Approved Section 4.55 (.....2.....) Modification Application

No.....2..... Granted on ...28 January 2020

Goulburn Hospital & Health Service Redevelopment

SITE PLAN - DEMOLITION - S4.55 MODIFICATION APPLICATION

DRAWING TITLE
PRECINCT PLANS - LEVEL 01 - S4.55 MODIFICATION APPLICATION

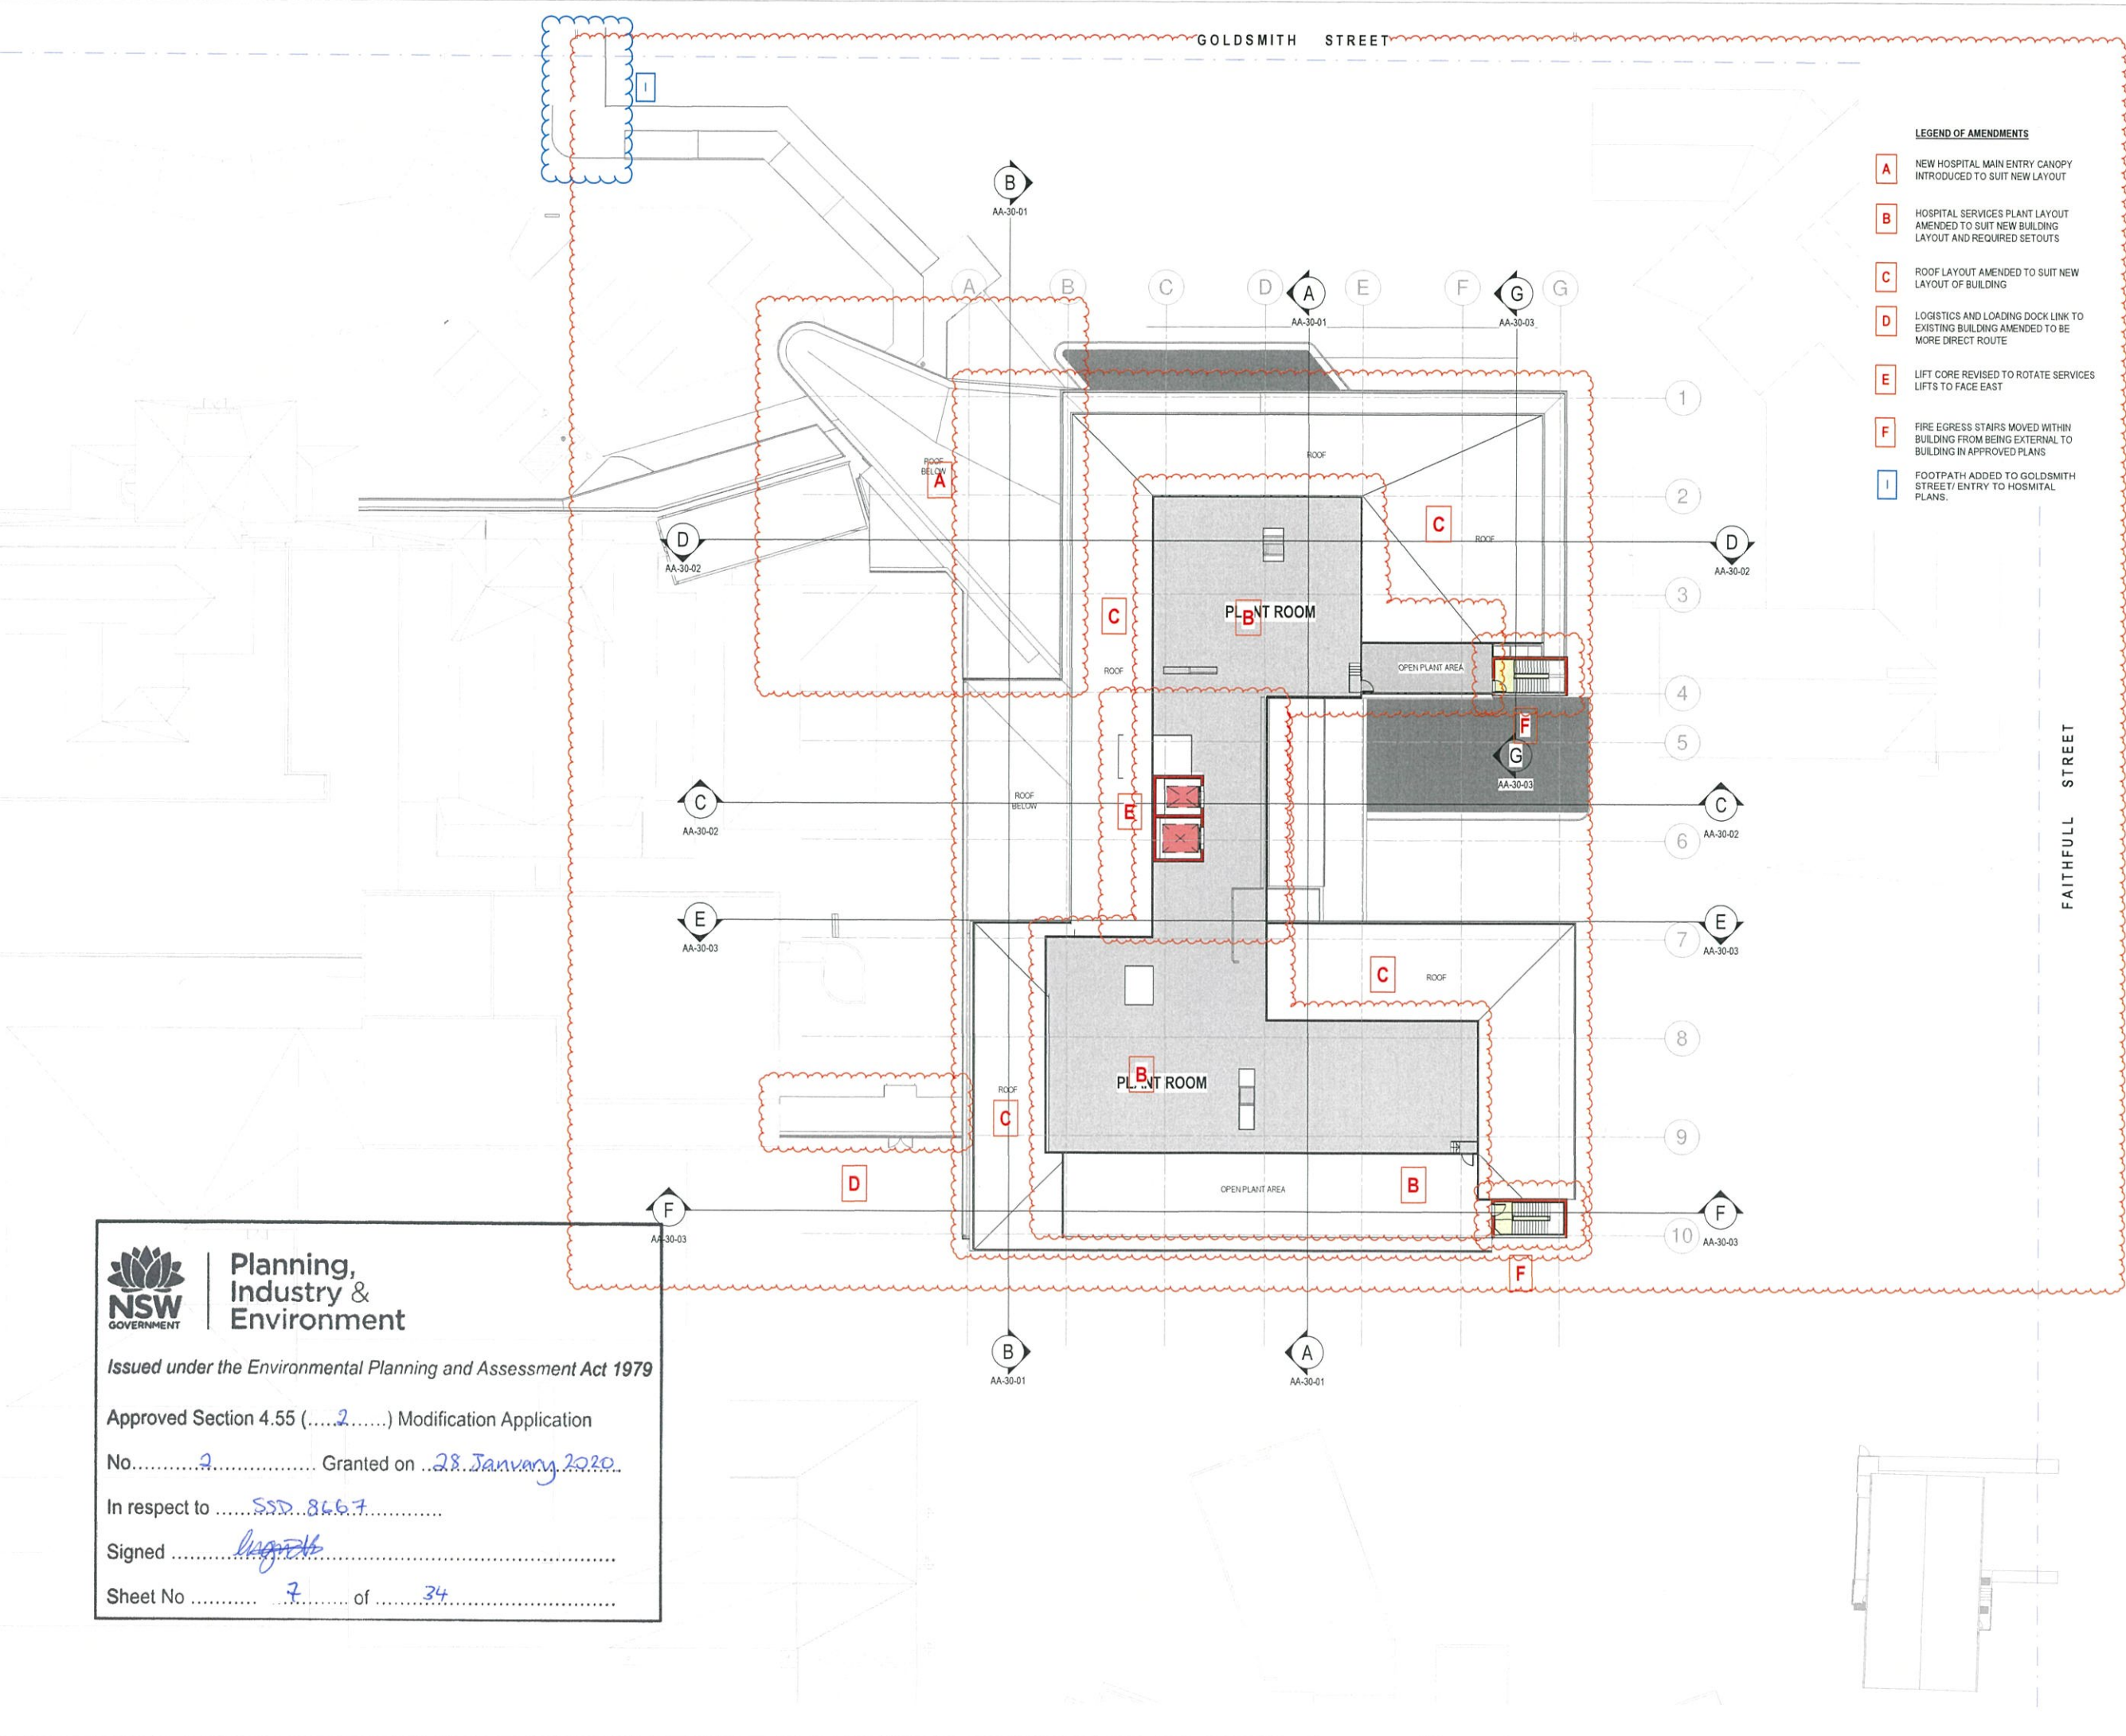
- A** NEW CANOPY OVER HOSPITAL MAIN ENTRY AND DROP-OFF AREA
- B** SURGICAL IPU PLANNING AMENDED FOR IMPROVED FUNCTIONALITY
- C** PERIOPERATIVE SERVICES AND DAY OF SURGERY DEPARTMENT PLANNING AMENDED FOR IMPROVED FUNCTIONALITY
- D** STERILE SUPPLY UNIT ADDED TO FUNCTIONAL LAYOUT WITHIN NEW BUILDING EXISTING STERILE SUPPLY UNIT WITHIN EXISTING BUILDING TO BE RE-PURPOSED
- E** LINK TO EXISTING BUILDING REMOVED AS NO LONGER REQUIRED
- F** BUILDING FOOTPRINT WIDENED AT LIFT CORE AND CENTRAL AREA LIFT CORE REVISED TO ROTATE SERVICES LIFTS TO FACE EAST
- G** FIRE EGRESS STAIRS MOVED WITHIN BUILDING FROM BEING EXTERNAL TO BUILDING IN APPROVED PLANS
- I** FOOTPATH ADDED TO GOLDSMITH STREET/ ENTRY TO HOSPITAL PLANS

SECTIONS AA & BB

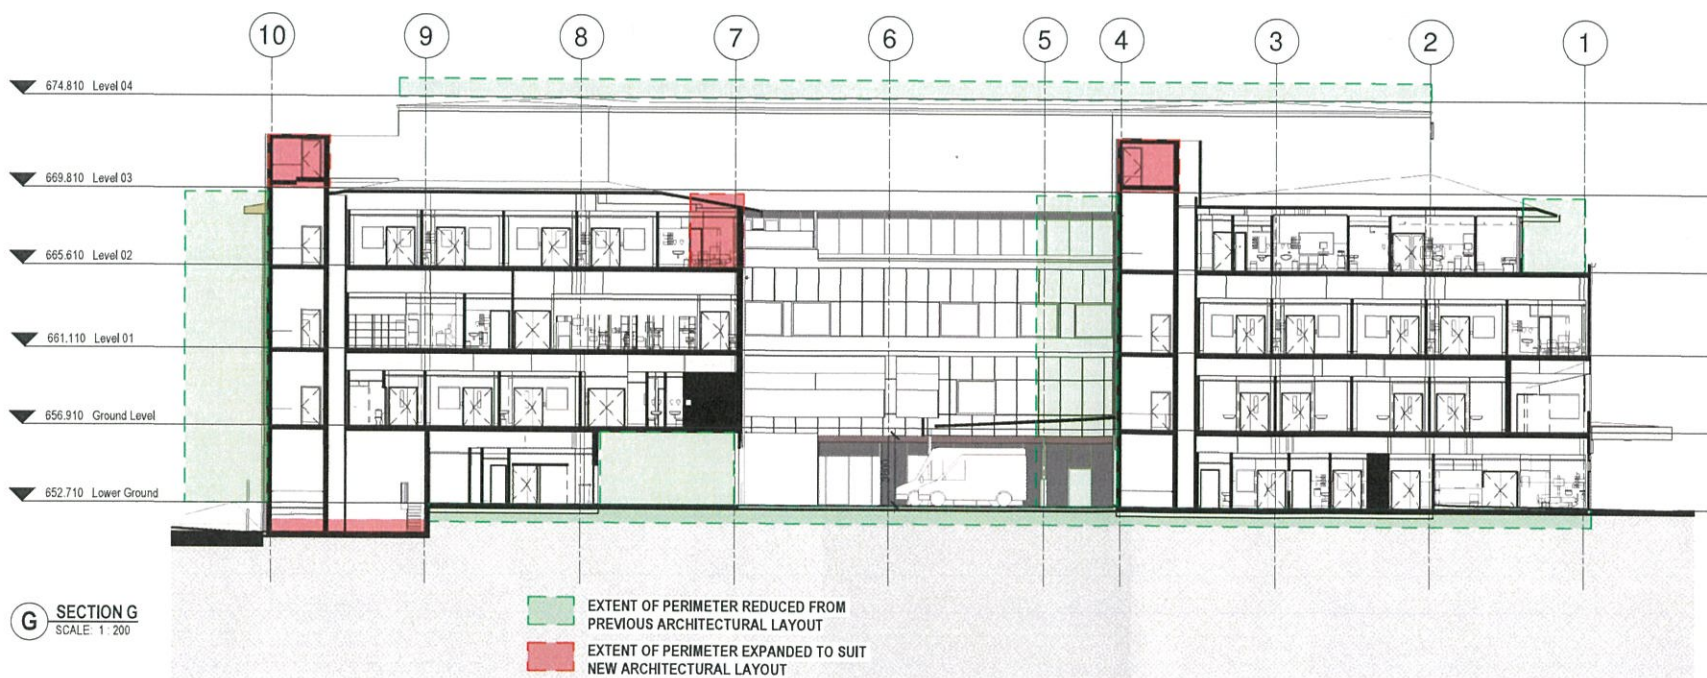
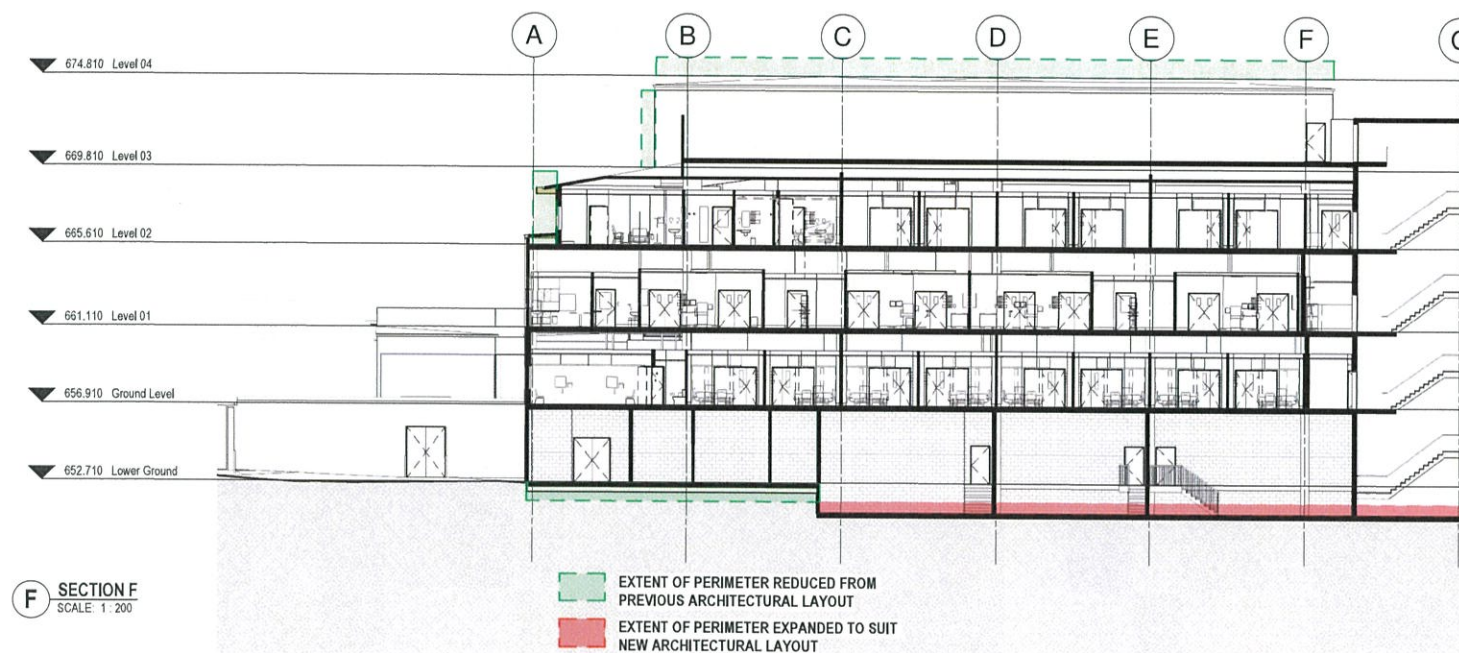
EXTENT OF PERIMETER REDUCED FROM
PREVIOUS ARCHITECTURAL LAYOUT
EXTENT OF PERIMETER EXPANDED TO SUIT
NEW ARCHITECTURAL LAYOUT

EXTENT OF PERIMETER REDUCED FROM
PREVIOUS ARCHITECTURAL LAYOUT
EXTENT OF PERIMETER EXPANDED TO SUIT
NEW ARCHITECTURAL LAYOUT

SITE PLAN

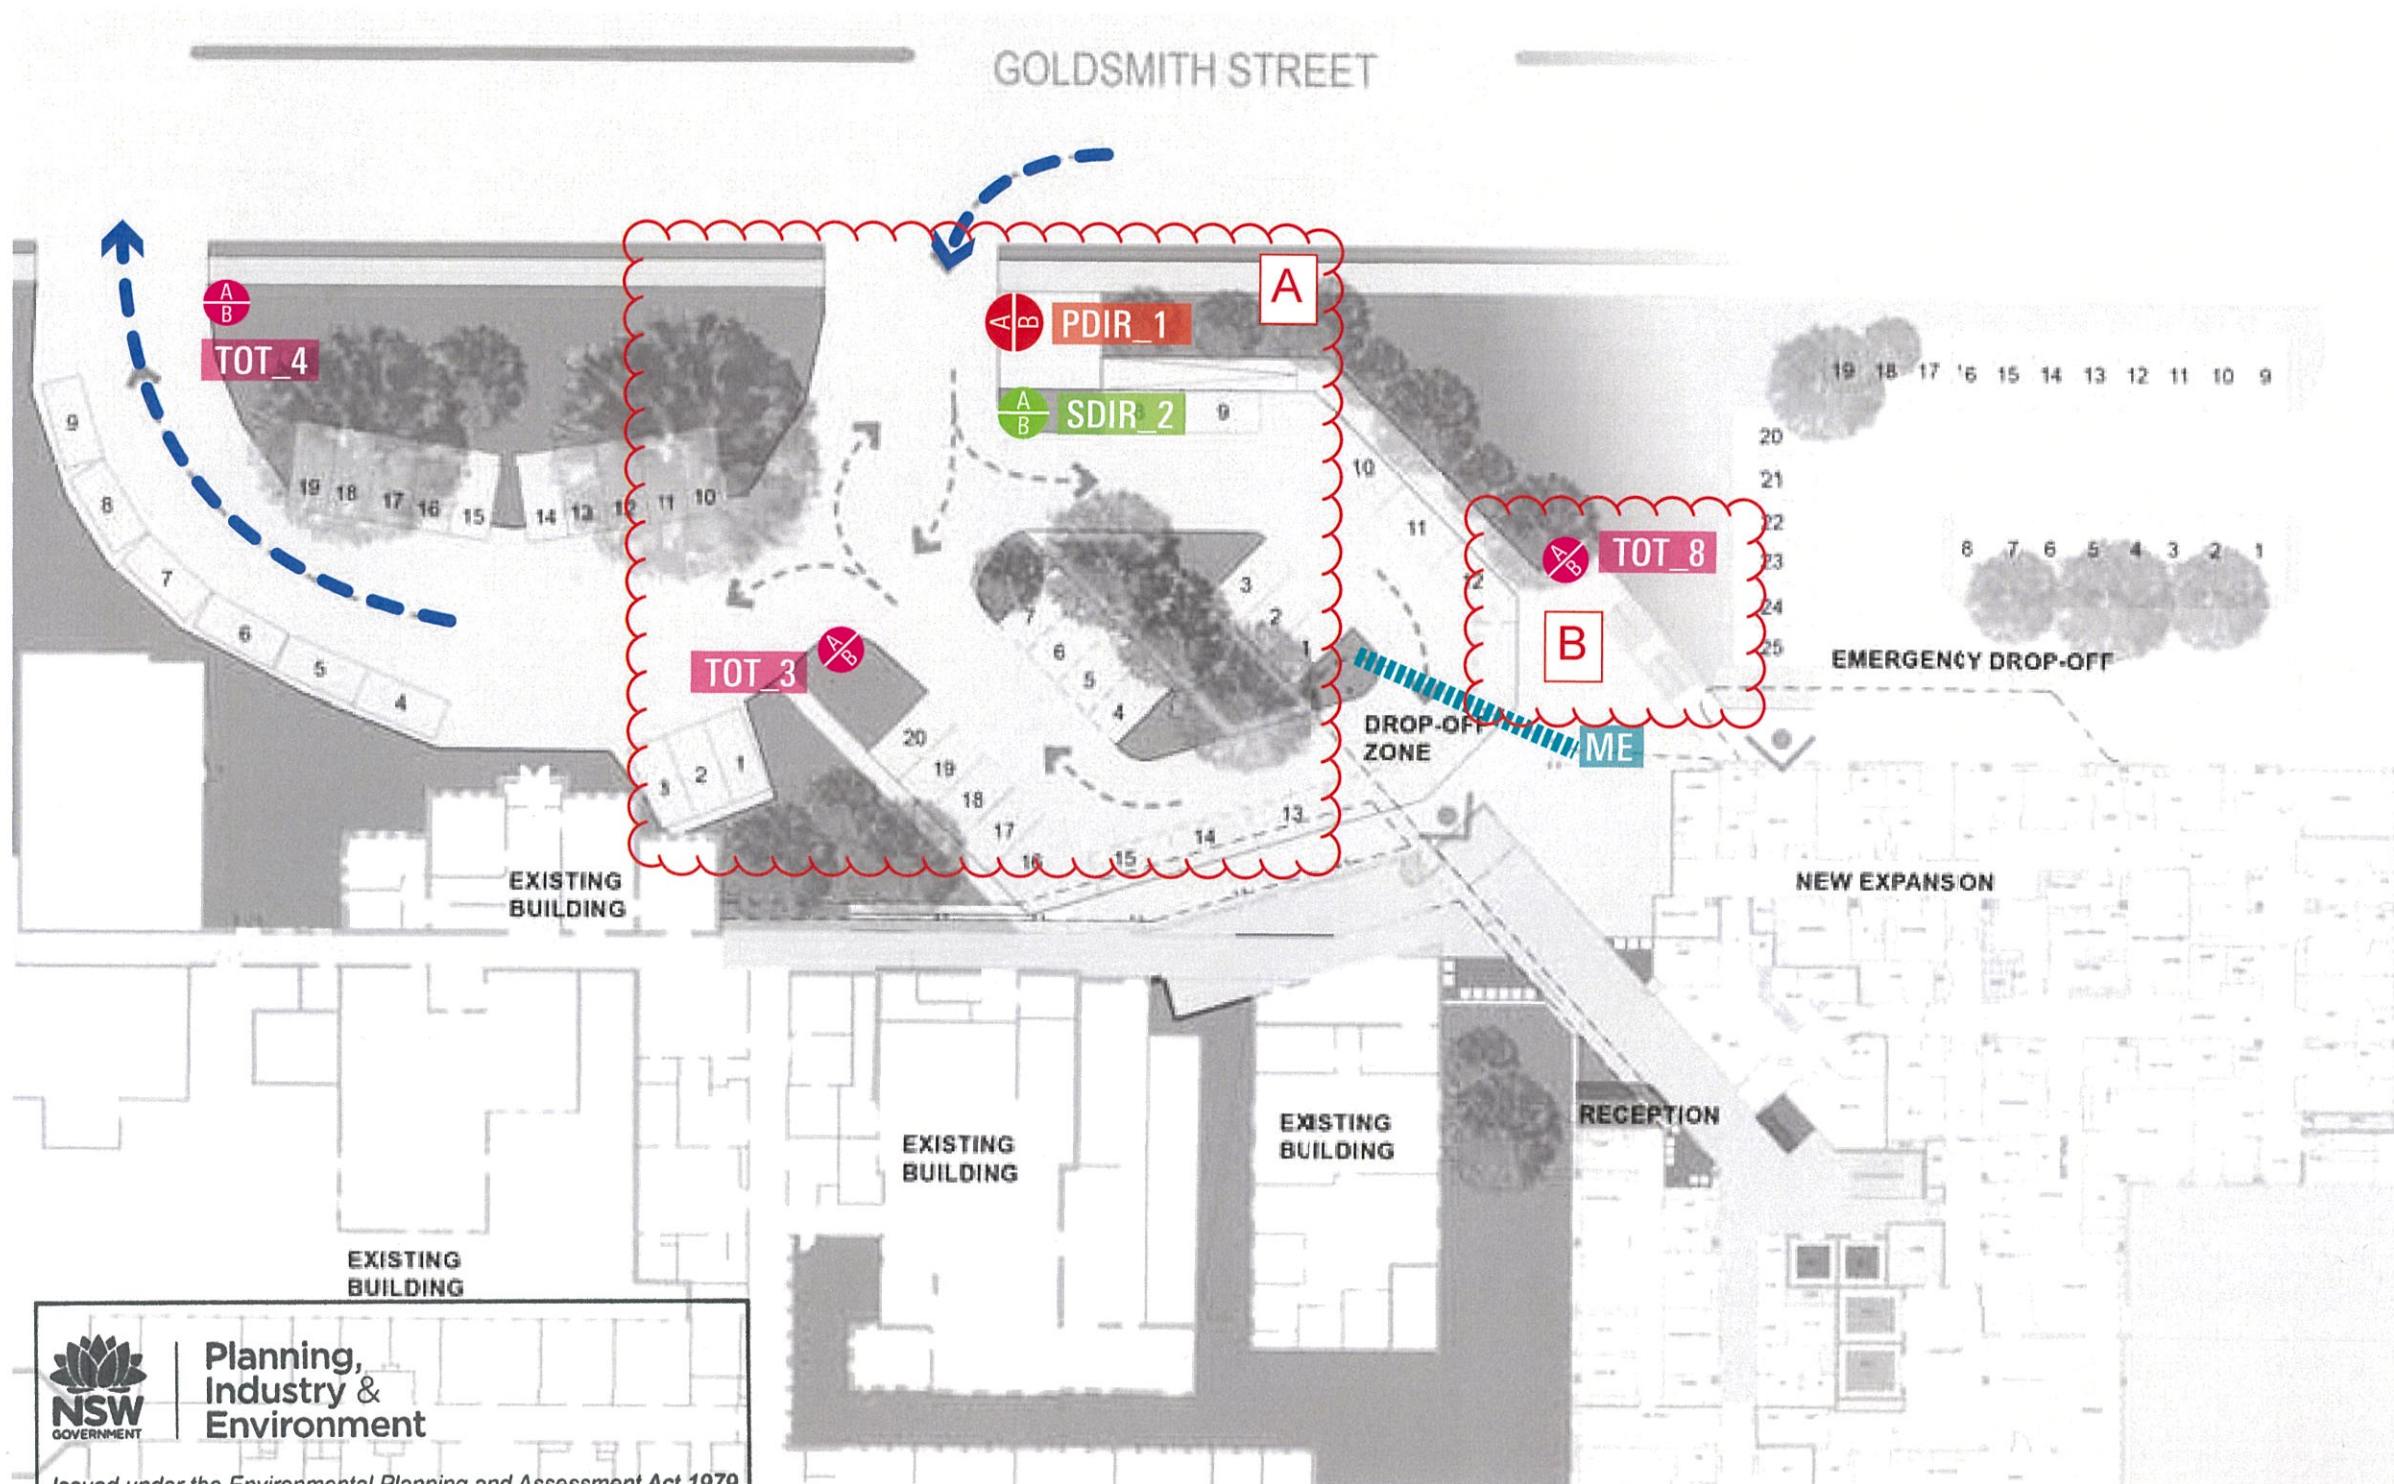
A POSITION OF OF EXTERNAL SIGNAGE HAS BEEN SLIGHTLY ADJUSTED TO MATCH THE LOCATION OF THE MAIN ENTRY POINTS. GENERAL LOCATION AND VISUAL APPROACH REMAINS THE SAME.

C BUS AND BICYCLE PARKING SYMBOLS HAVE BEEN ADDED TO DIRECT PEDESTRIANS TO THE BUS STOP ON GOLDSMITH ST AS WELL AS THE PUBLIC BICYCLE PARKS AT THE MAIN ENTRY AND THE EMERGENCY CAR PARK.
